Final Decision

Planning Commission

File number(s): CU 2019-07, DR 2019-13, EXCP 2019-07, & PP 2019-03

Woodburn High School (H.S.) Addition/Expansion & Redevelopment / "Career & Technical Education (CTE)" Addition

OVERALL EXISTING SITE PLAN

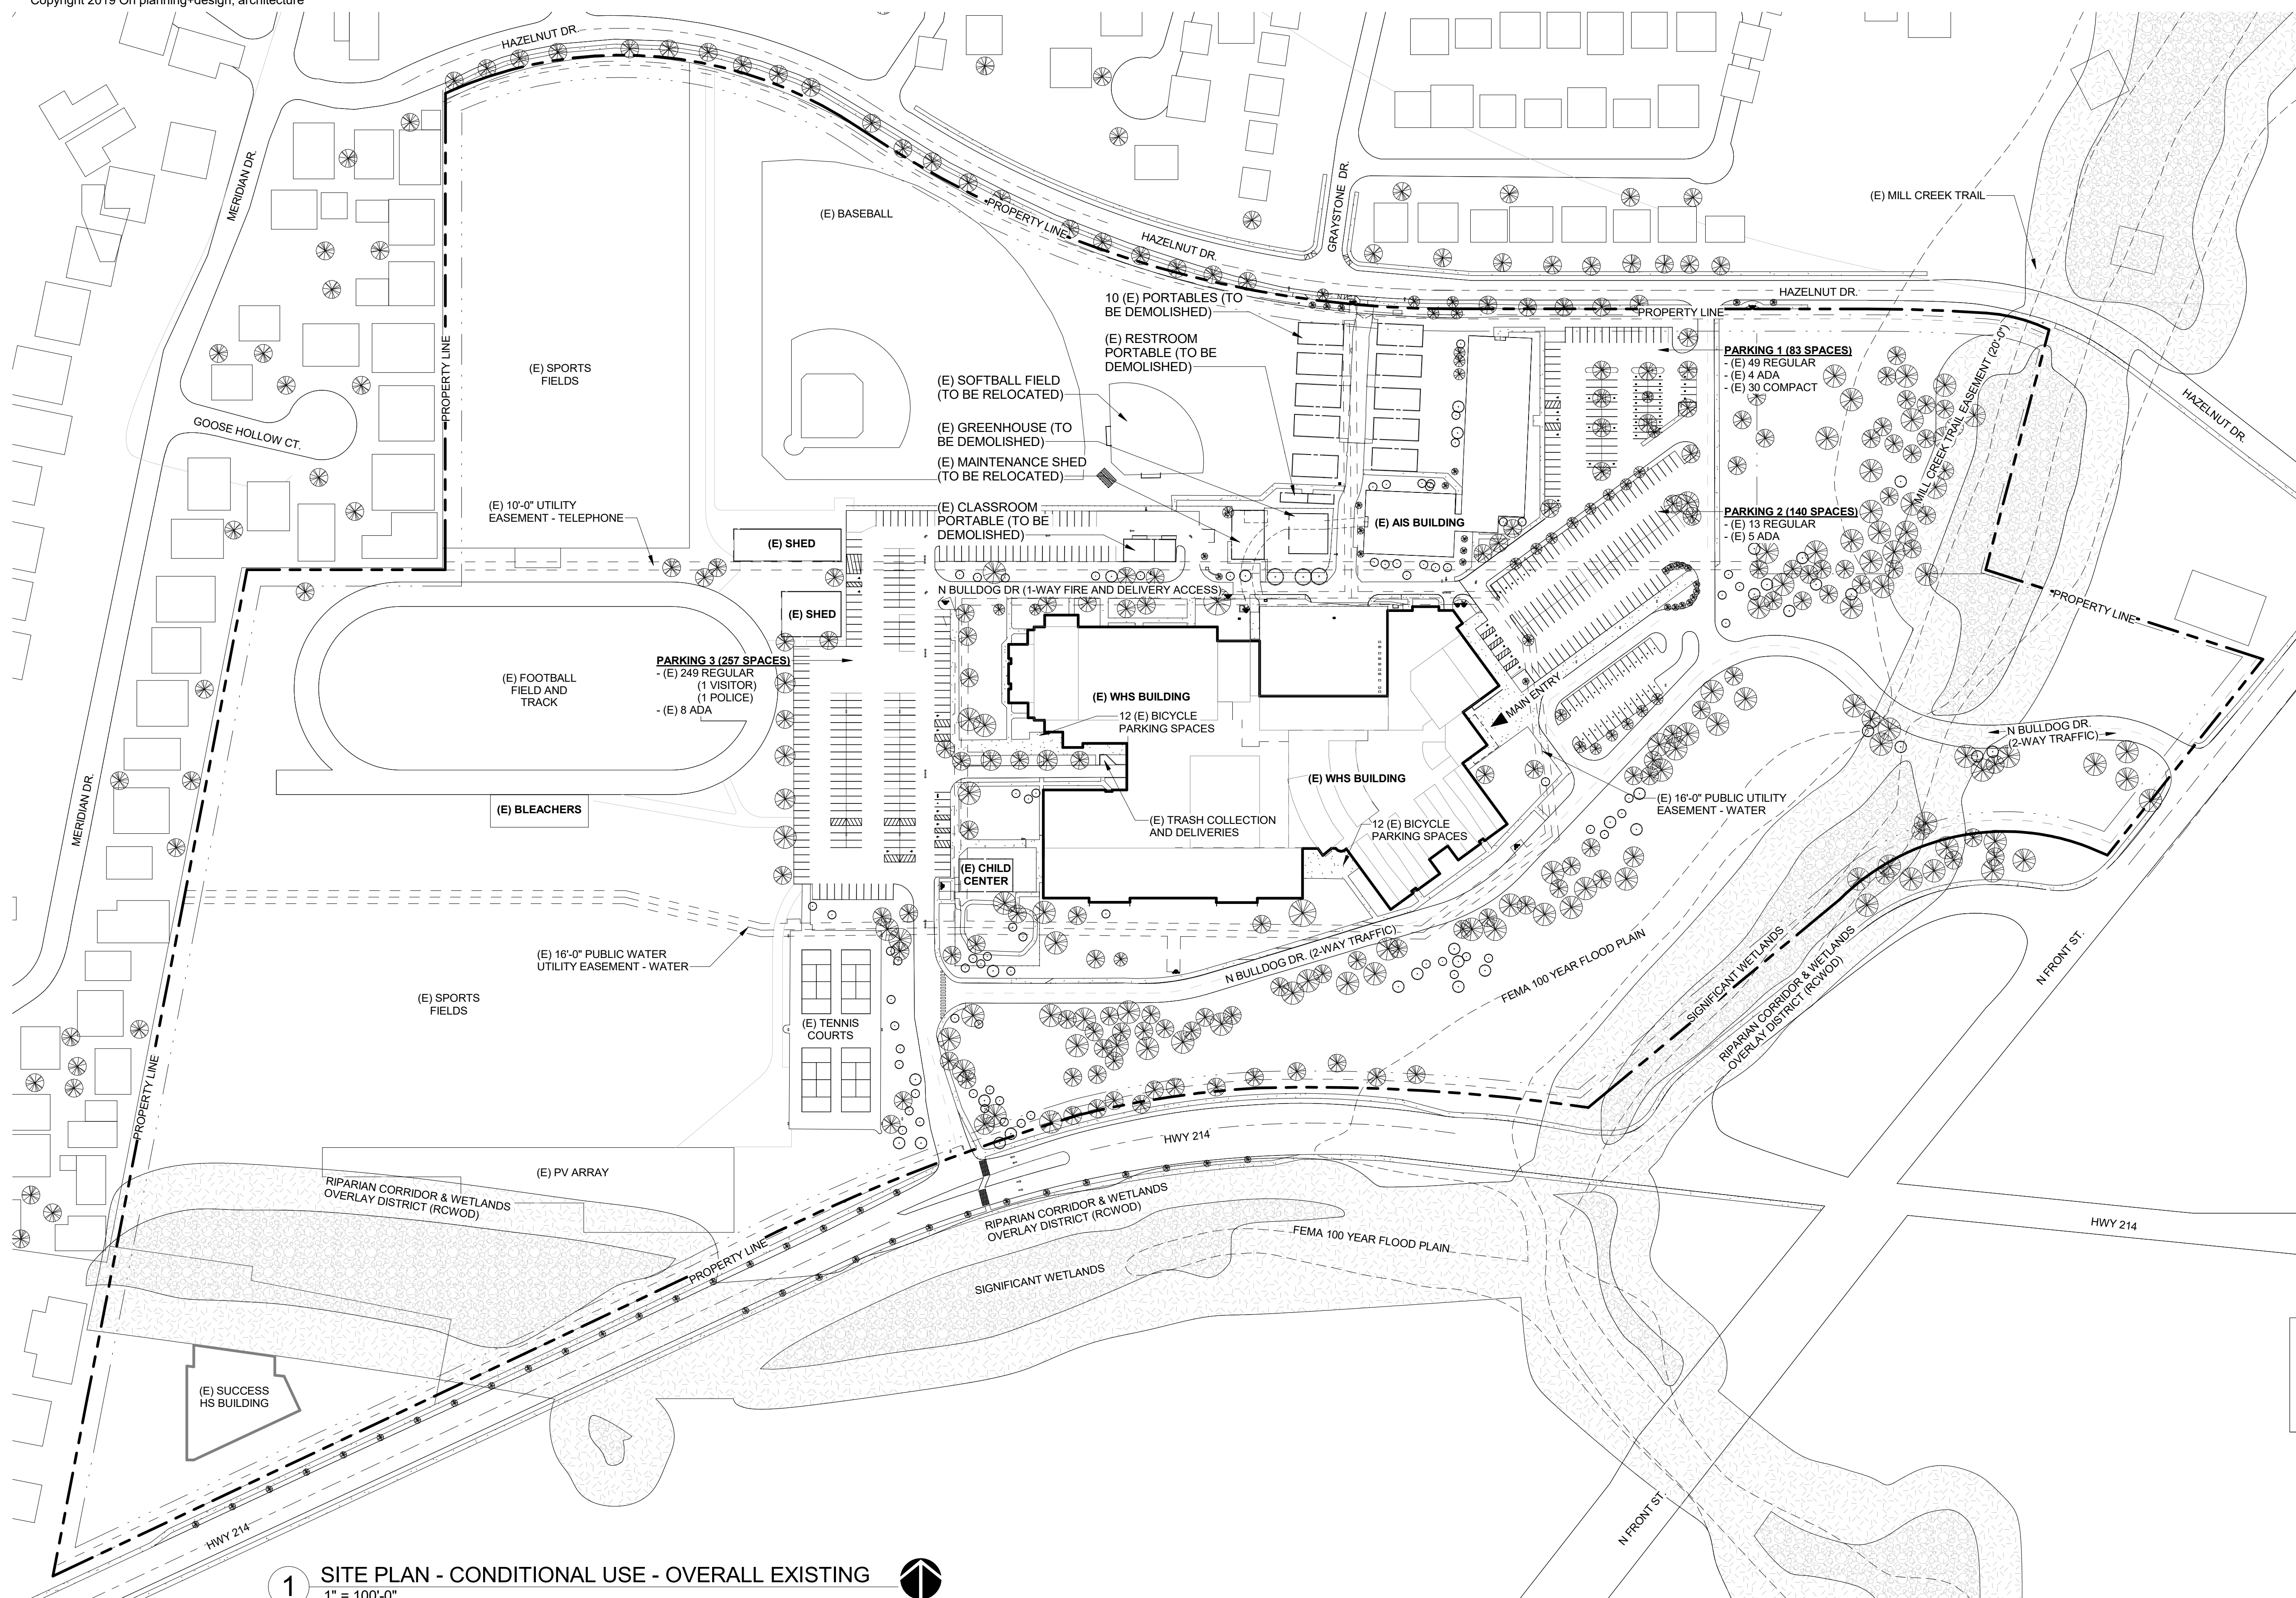
C9. Modular buildings / modulares: Consistent with the land use review plan set submitted February 4, 2020, Sheets CU-A00 Overall Existing Site Plan and CU-A01 Overall Master Plan, the number of modular buildings shall decrease by at least ten (10) by Phase 1. The removal of modular buildings is due by building permit final inspection for Phase 1. (The City may later supersede this condition by taking action on a future land use application submittal as to allow one or more modular buildings.)

OVERALL MASTER PLAN

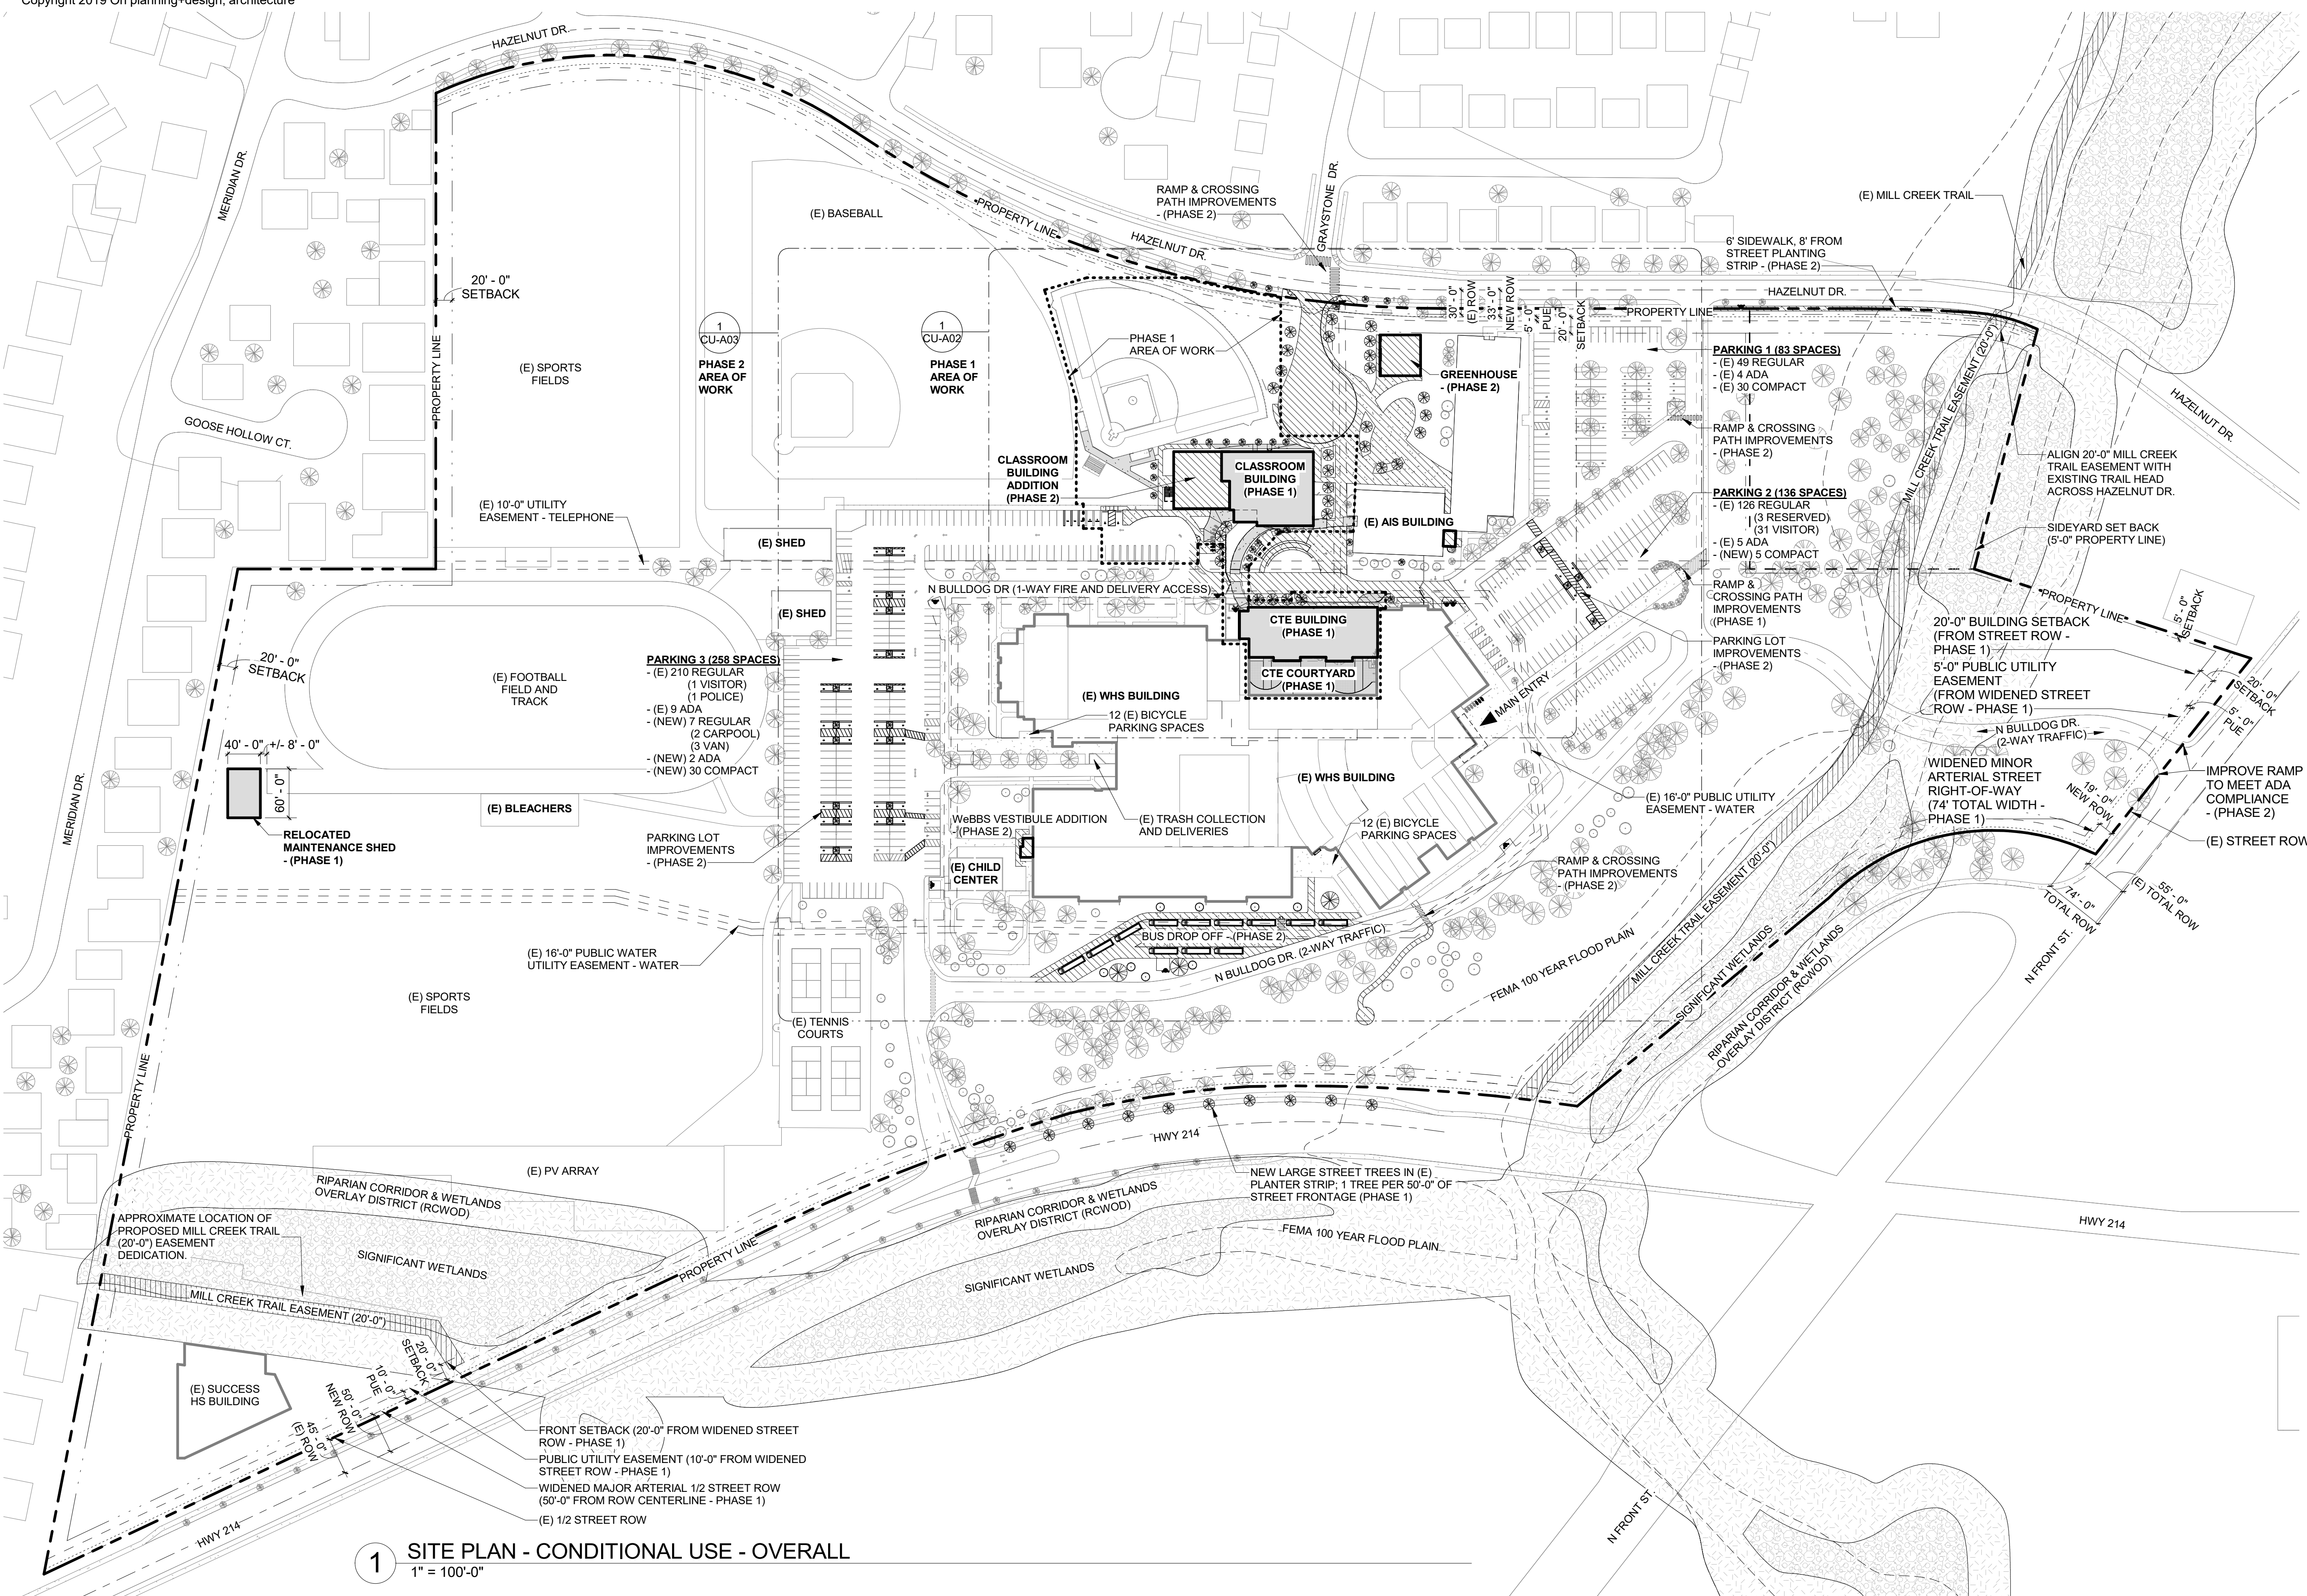
- a. On-site: The applicant shall make ADA-compliant the walkway ramp transition at the location Sheets CU-A01 & 3 illustrate and note for Phase 1.
- b. Highway and road sidewalks: See Street Exception (EXCP) conditions.

- a. East front student/visitor: As proposed, per Sheets CU-A01 & 3 and L01 & 2, the applicant shall modify the parking area to stripe a walkway at least six (6) feet wide across the drive aisles and install and plant four landscaped islands with trees. The middle two islands shall each be at least fifty-two (52) square feet within inside of curbing with narrowest dimension of six-and-a-half (6½) feet minimum within inside of curbing. The trees shall conform to Table 3.06B. Additional or altered compact stalls shall be striped with "C", "COMPACT", or "COMPACT ONLY".
- b. West rear staff: As proposed, per Sheets CU-A01 & 3 and L01 & 2, the applicant shall modify the parking area to stripe walkway crossings of the east drive aisle.
